TRANSMITTAL OF THE RESPONSE TO DEPARTMENT OF ENERGY (DOE) COMMENTS ON THE DRAFT GROUNDWATER PLUME TREATMENT SYSTEMS OPERATIONS AND MAINTENANCE (O&M) MANUAL AND THE DRAFT 2003 ANNUAL REPORT FOR THE ROCKY FLATS ENVIRONMENTAL TECHNOLOGY SITE (RFETS) GROUNDWATER PLUME TREATMENT SYSTEMS - KLW-042-05

Response to Department of Energy (DOE) Comments on the Draft Groundwater Plume Treatment Systems Operations and Maintenance Manual

Response to DOE Comments on the Draft 2003 Annual Report for the Rocky Flats Environmental Technology Site Groundwater Plume Treatment Systems

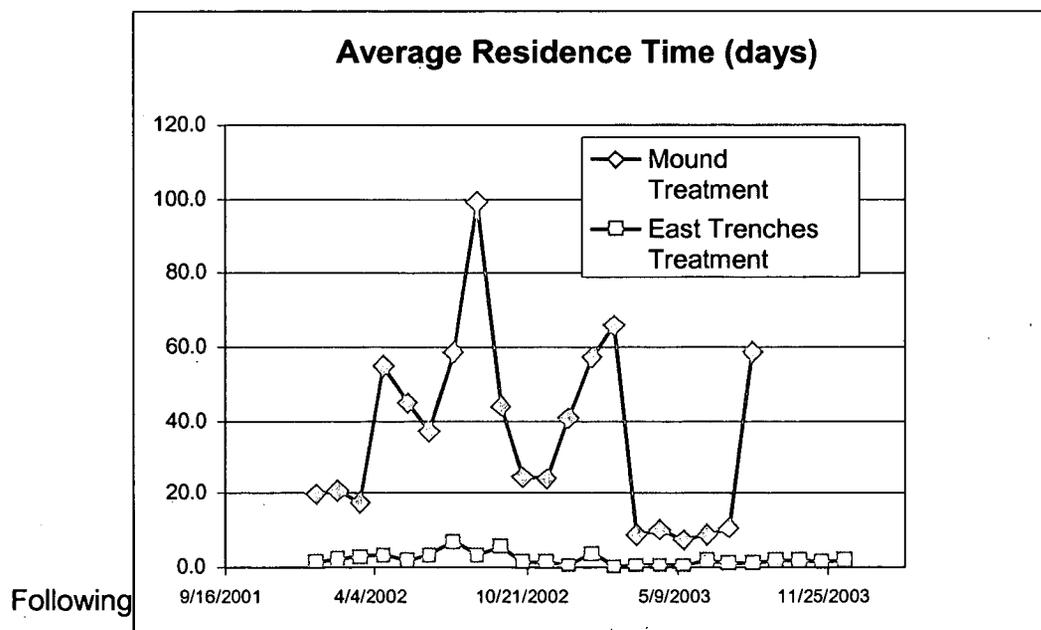
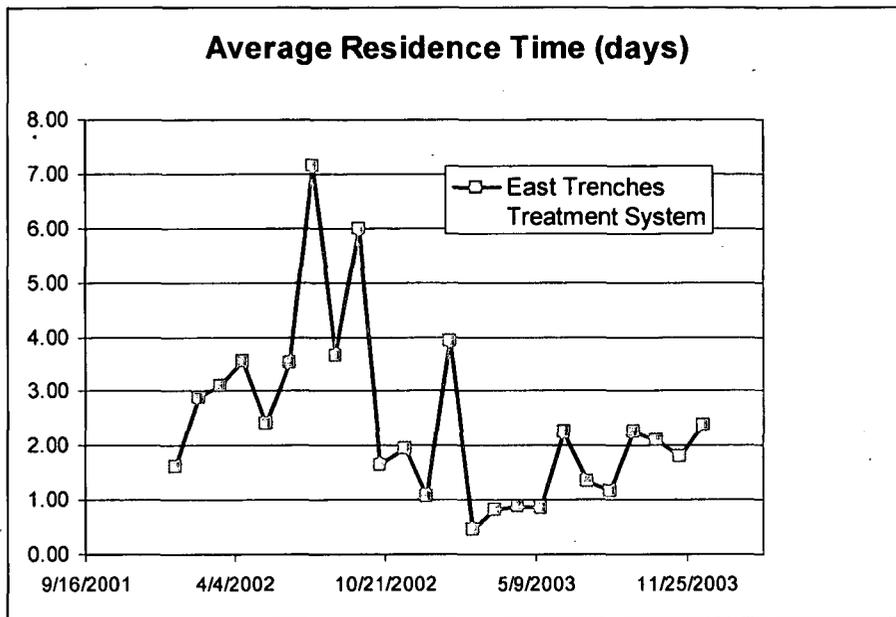
(1) **Comment:** Data are provided to help evaluate the performance of the treatment cells. However, the concentration data is provided as ranges in one table rather than the specific values of individual samples. It is not clear even how many samples were analyzed (if only 2, it would be easy to present both).

Any thoughts on whether 2 samples is sufficient to characterize the system performance. It may not be appropriate to use chemical results from a few samples to represent the entire year - need to provide some defense of this by looking at the variability of the data from closer spaced samplings.

Treatment efficiency of VOC by ZVI is rate controlled and therefore it is critical that we know the rate of fluid movement through the ZVI. This is best expressed as residence time. I assume that there are some residence time requirements built into the design. These are likely based on laboratory treatability studies and should be updated by data from the treatment cells. In summary, residence times associated with each set of data should be reported.

Response: The format for tables was based on the format used in past reports. In 2003, the Mound Plume Treatment System was sampled twice. The East Trenches Plume Treatment System influent was sampled twice in 2003 and the effluent was sampled four times. The Solar Ponds Plume Treatment System influent was sampled monthly. The effluent on the Solar Ponds Plume Treatment System was scheduled for monthly sampling; however, sometimes there was insufficient flow at the sampling point to get a sample.

The sampling frequency is in accordance to the Interim Measure/Interim Remedial Action decision documents for each system. This frequency is sometimes increased to evaluate system performance.

Residence times for the Mound Plume and East Trenches treatment systems for both 2002 and 2003 are shown below, except for the end of 2003 when little flow due to the drought.

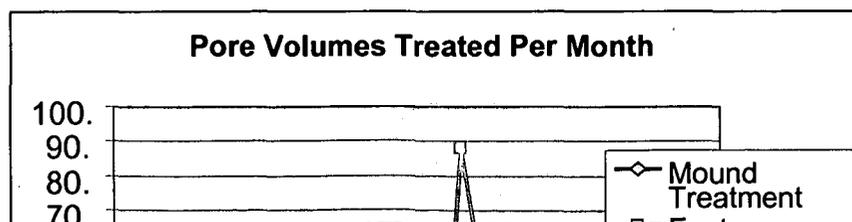
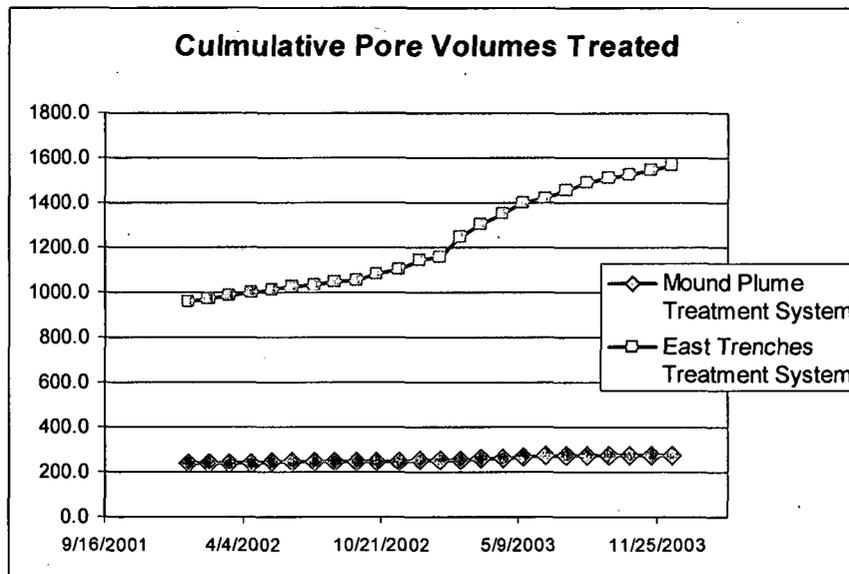
(3) Comment: History of operation. Although this report only covers year 2003, it would be useful to have a diagram or table that provides historical information about the treatment cells (when was ZVI changed out?, any unusual events?, any design changes such as use of different types of ZVI etc). A plot of date/time on X axis and volume treated (best expressed as pore volumes to make easy comparison to other ZVI projects)

Response: A maintenance log was provided separately. In addition, quarterly and annual reports are attached that cover all of the years of operation prior to 2003. Pore volumes treated per month as well as cumulative pore volumes have been plotted for 2002 and 2003 and are presented below:
